Location Address: 2231 FILLMORE ST and 2224 PIERCE ST, HOLLYWOOD FL 33020

Explanation of Request: NEW CONSTRUCTION, 63 UNIT, RENTAL APARTMENT BUILDING

**SUBJECT:** Preliminary Site Plan review for a 63 Unit residential development.

# FILLMORE STREET APARTMENTS

PAVING, GRADING & DRAINAGE PLAN

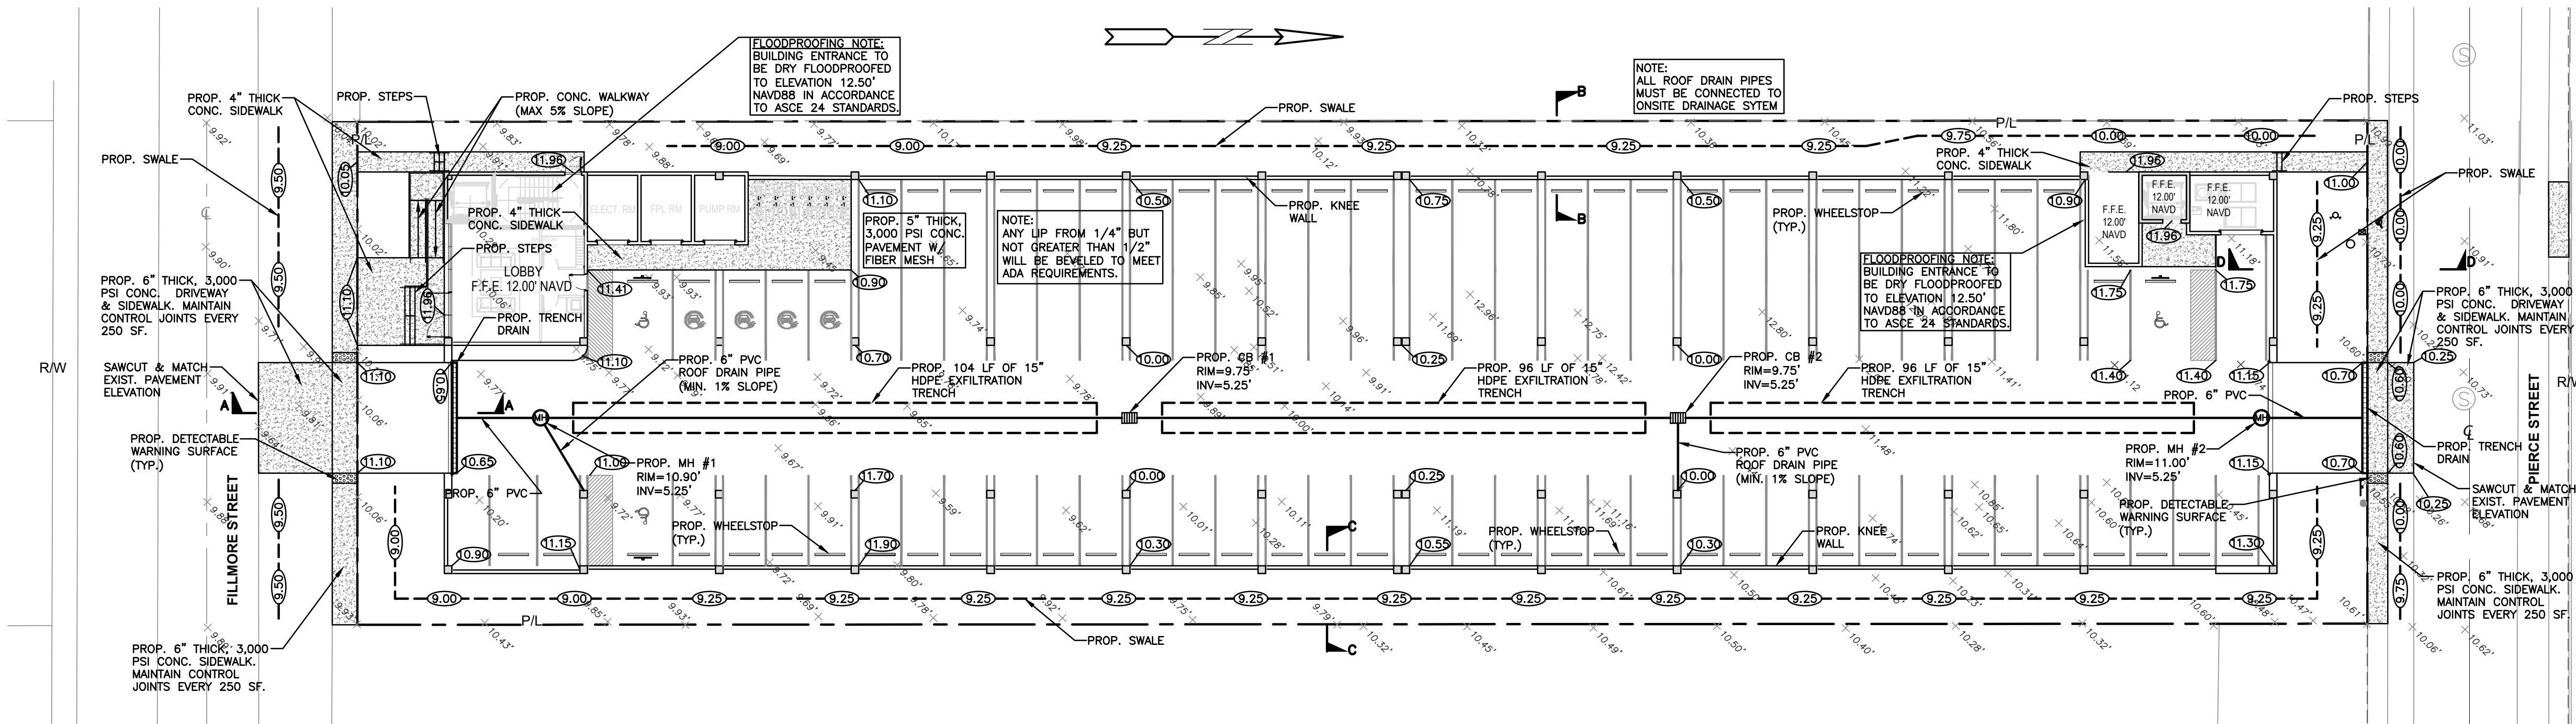
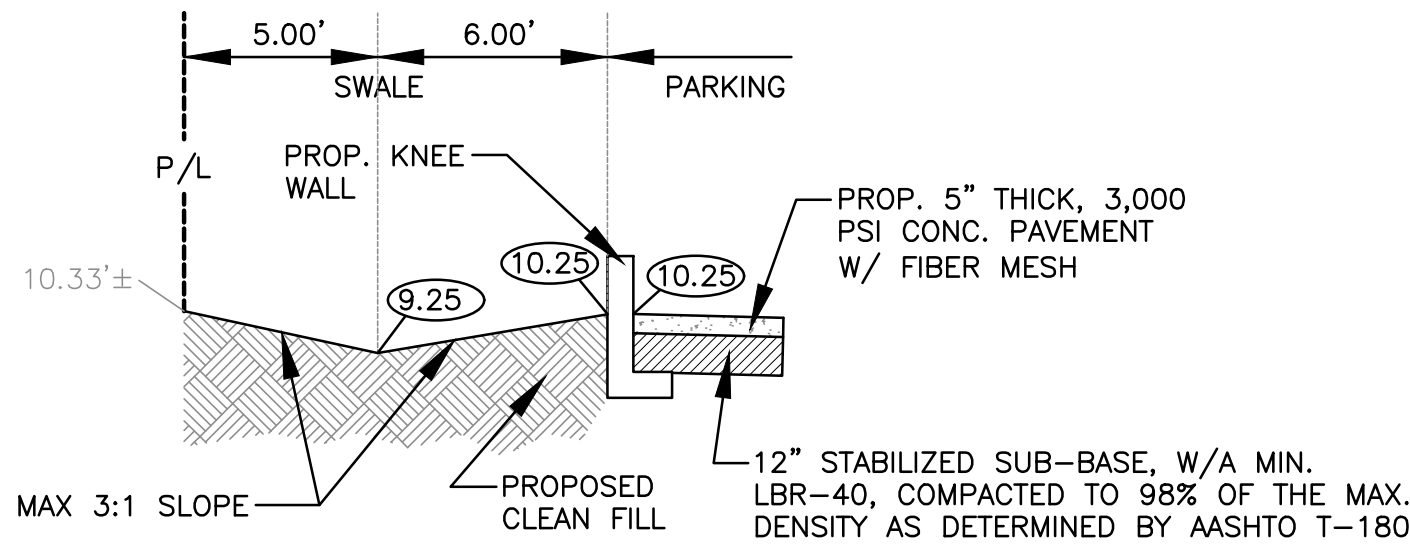
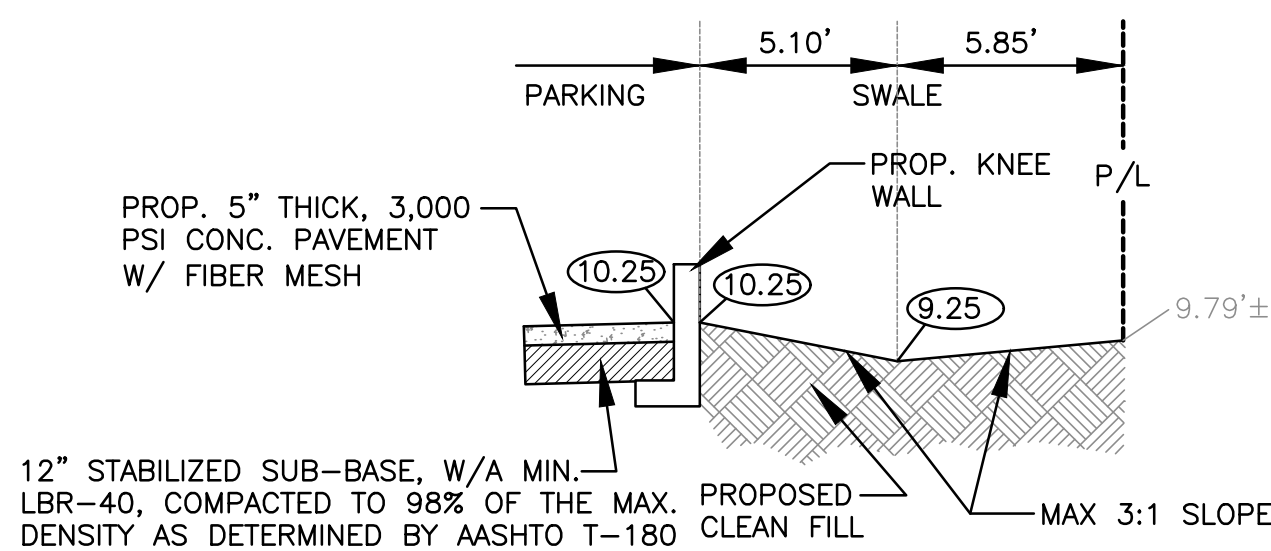
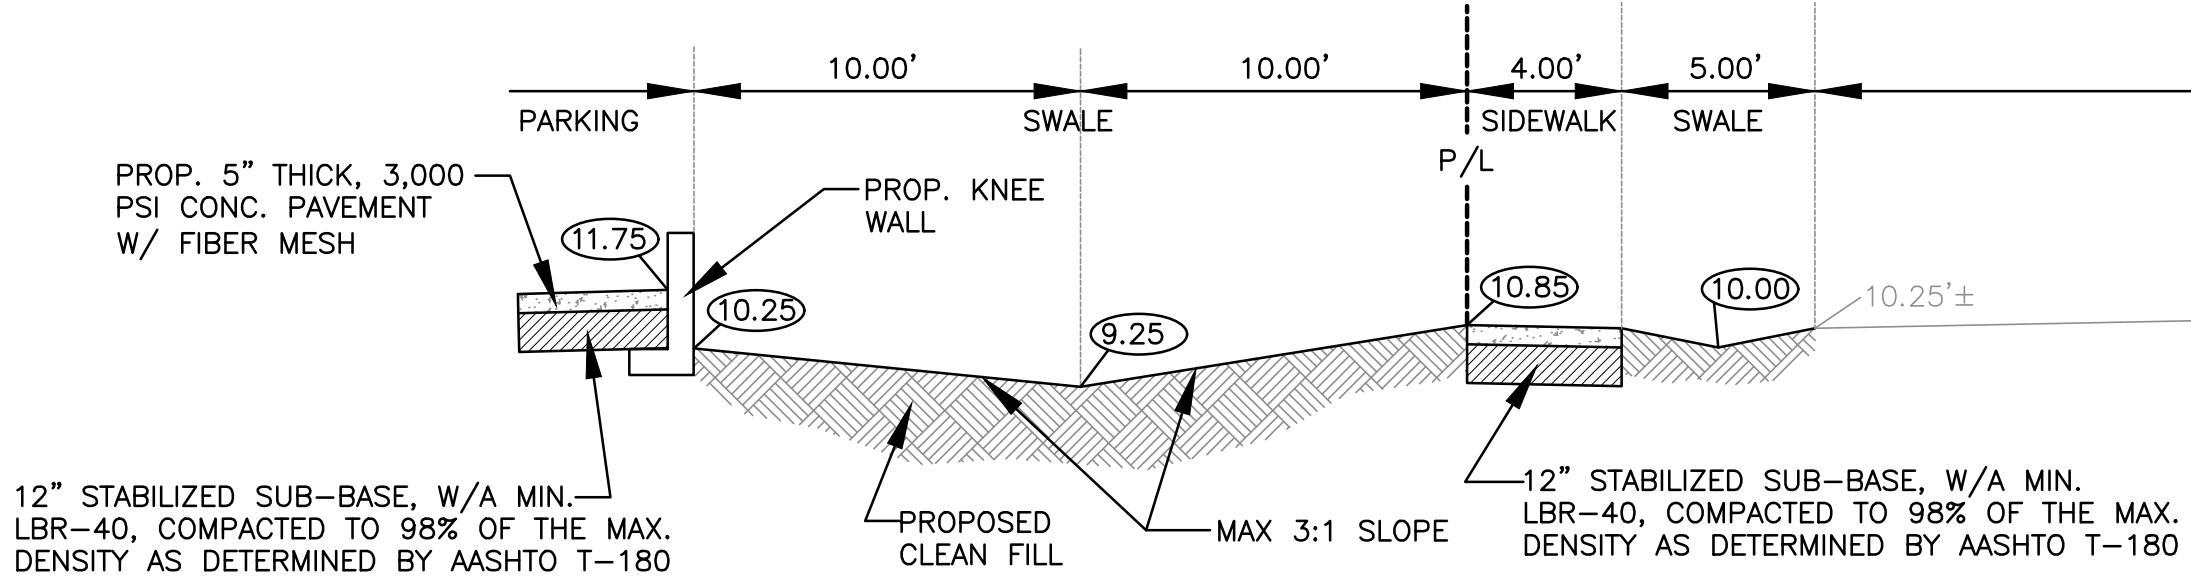
6. Indicate FFE for all enclosed areas on the ground floor.  
**RESPONSE: Please see sheet C2.**
7. Provide perimeter cross sections across all property limits including transition areas meeting adjacent property grades.

**RESPONSE: Please see cross-sections on sheet C2.**
8. Ensure all stormwater is retained onsite.  
**RESPONSE: The proposed design will retain all stormwater onsite. Please see sheet C2 and attached drainage report.**

9. Indicate how roof drainage will be collected and connected to the onsite drainage system.  
**RESPONSE: Roof drains will connect to the proposed onsite drainage system. Please see sheet C2.**

**RESPONSE: Please see FFE on sheet C2. The building will be floodproofed to meet the City's 18-inches above crown of road elevation requirements.**
